AN ORDINANCE approving Change Order Number 26 in connection with the Water Pollution Control Plant Expansion, Division I.

Subject Change Order #26, Water Pollution Control Plant Expansion Div. I

CHANGE ORDER NO. 26

CHANGE ORDER NO. 26 - MISCELLANEOUS ADDITIONAL WORK

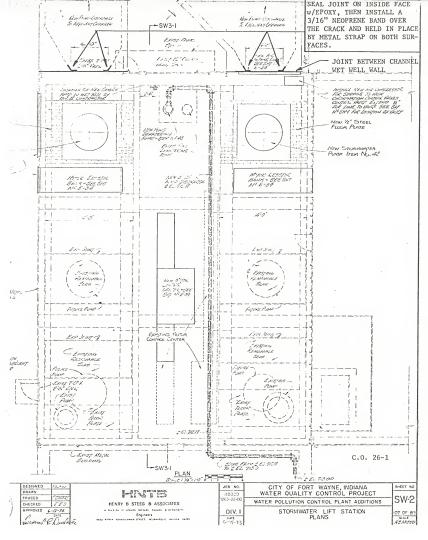
ITEM NO. 3 - CONDUIT SYSTEM RELOCATION DUE TO AIR PIPING REVISION AT AERATION TANKS 1, 2, AND 3

Change Order No. 7, Item 1, revised the air piping into Aeration Tanks IA, 2A, and 3A per the attached drawing. The cost for only the mechanical portion of these changes was included in Change Order No. 7. The electrical changes involved a new conduit system in the lower level pipe gallery to feed the three air flow control butterfly valves and the relocation of existing conduit and wiring that obstructed the pipe entrance into the box channel at Aeration Tank IB. Prior to this change, the wiring for the valves would have been incorporated in the conduit system for the three sluice gates located on the upper level.

ITEM NO. 4 - RELOCATION OF EXISTING SIGNAL CABLE TO LOCATION OUTSIDE OF NEW SUBSTATION SECURITY FENCE AT STORM WATER STATION

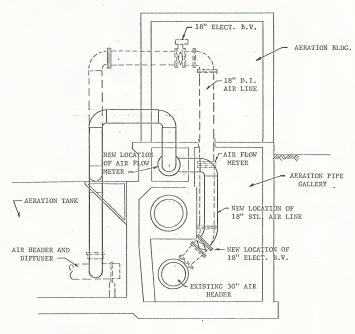
Change Order No. 13, Item No. 3, relocated an existing 3-inch PVC water line from the location of the power utility's new electrical substation. A 50-pair telephone cable buried with the water line was also relocated along with the water line. The cost for only the mechanical portion for

these changes was included in Change Order No. 13. The electrical work involved the installation of approximately 140 L.F. of 1-inch PVC conduit and 50-pair telephone cable.

Furnish all labor and materials to relocate the 50-pair telephone cable per drawing C.O. 26-3 \$1,402 Material

C.O. 26-2

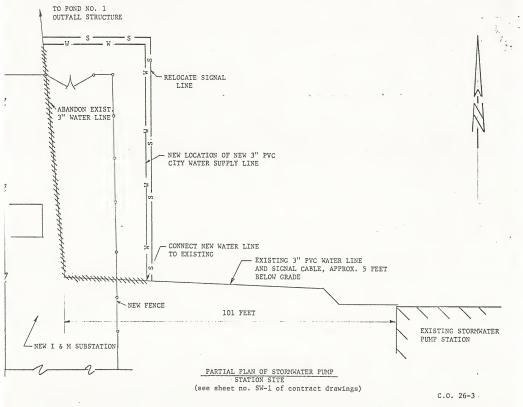
ORIGINAL DESIGN
PROPOSED CHANGE

SECTION THRU EXISTING
AERATION PIPE GALLERY
(same as section EA3-1
of contract drawings)

PROJECT Water Quality Control Project OWNER City of Fort Wayne, Indiana DIVISION/SECTION I - Water Pollution Control Plant Additions CHANGE ORDER NO. 26 TO: Hagerman-Shambaugh, Joint Bidders c/o Hagerman Construction Company 510 West Washington Blvd. P.O. Box 10690 Fort Wayne, Indiana 46853 You are hereby authorized to make the following additions and/or deductions to your contract amount. Previous Net Change Revised Contract Amount Increase Decrease (Add) Contract Amount TOTAL \$ 22,165,978.39 \$ 20,256.00 \$ -0-\$ 20,256.00 \$ 22,186,234,39 Add Deduct Description of Change: \$4,000 Item No. 1 Stormwater Discharge Channel Reinforcement Furnish all labor and materials to reinforce the joint of the new stormwater effluent channel to the existing stormwater station wet well wall per Drawing C.O. 26-1. Material \$2,100 Labor \$1,380 \$ 347 Overhead \$ 173 Profit Total \$4,000 Item No. 2 Set Relays and Breaker Trip Points on all Switchgear per Short \$2,304 Circuit and Protective Device Coordination Study dated March, 1979 \$1,338 Material Labor \$ 570 Overhead \$ 286 \$ 110 Profit Tota1 \$2,304 Item No. 3 - Conduit System Relocation Due to \$7,754 Air Piping Revision at Aeration Tanks 1,2, & 3 Furnish all labor and materials to relocate existing and extend new conduit systems per drawing C.O. 26-2. \$1,254 Material \$5,489 Labor Overhead \$ 674 \$ 337 Profit \$7,754 Total
